APPEAL SUMMARY

Appeal ID: 14923	Project Address: 212 NE 79th Ave
Hearing Date: 4/12/17	Appellant Name: Kevin Partain
Case No.: B-014	Appellant Phone: 5037845984
Appeal Type: Building	Plans Examiner/Inspector: Gail Knoll
Project Type: commercial	Stories: 3 Occupancy: R-2 Construction Type: V-B
Building/Business Name:	Fire Sprinklers: Yes - All Three Levels
Appeal Involves: Erection of a new structure	LUR or Permit Application No.: 16-277816-CO
Plan Submitted Option: pdf [File 1]	Proposed use: Residential

CODE ANALYSIS FOR NEW 6-UNIT 3-STORY APARTMENT BUILDING:

3rd FLOOR PLAN

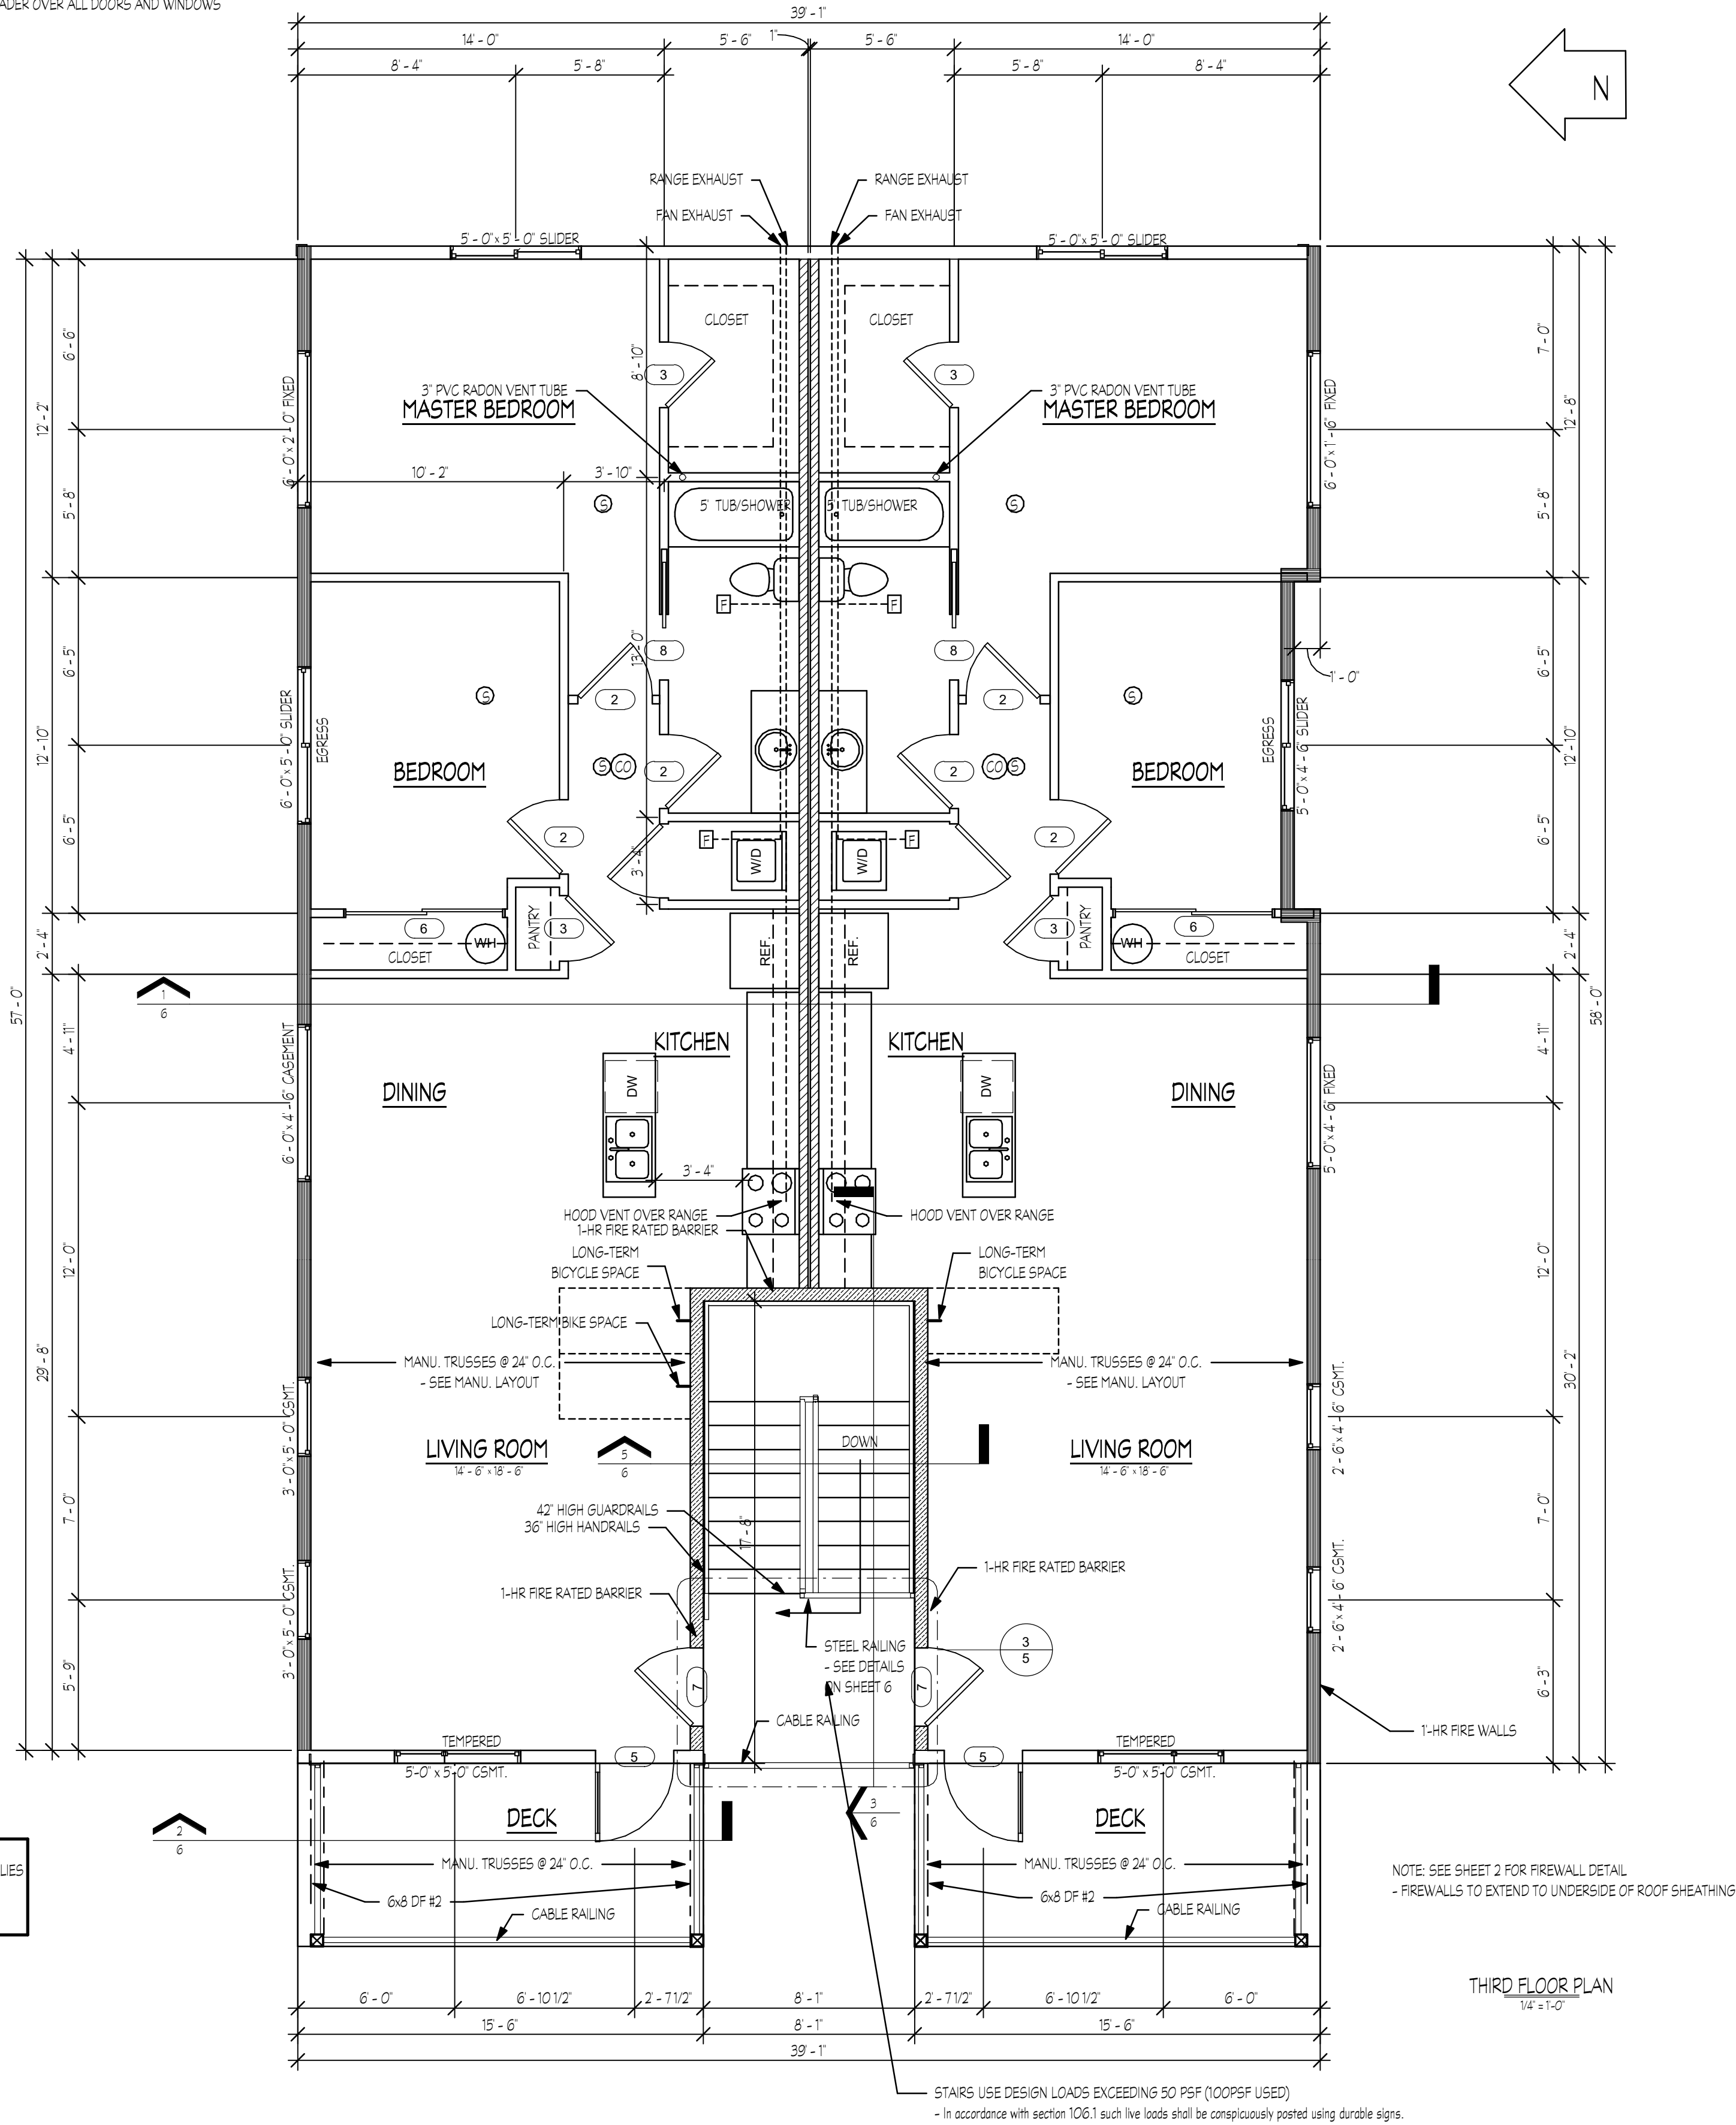
Requires 1206.2 require yards of 3' in width for buildings two stories or less. The minimum width of the yard is to be increased 1' for each additional story. The South wall line of a three story building is required to be 4' from the property line.

Proposed Design The proposed design is for a three story apartment building with a 3' setback between the south wall & the south lot line. The middle bedroom on the south side of the 3rd level is proposed to be recessed 1' from the remainder of the wall plane to provide that room with 4' of separation from the south lot line to ensure adequate natural light & ventilation. The master bedroom & the living/dining room will get the natural light & ventilation from the windows at each end of the structure.

Reason for alternative The alternative design is requested to avoid a complete re-design of the structure. As mentioned previously, the proposed design will provide the middle bedroom with 4' of separation from the south lot line to ensure adequate natural light & ventilation. The master bedroom & the living/dining room of that unit will get the natural light & ventilation from the windows at each end of the structure.

Provide 4 foot yard width for 3rd Floor bedroom on South side of building: Denied. Proposal does not provide equivalent ventilation. Appellant may contact John Butler (503-823-7339) with questions.
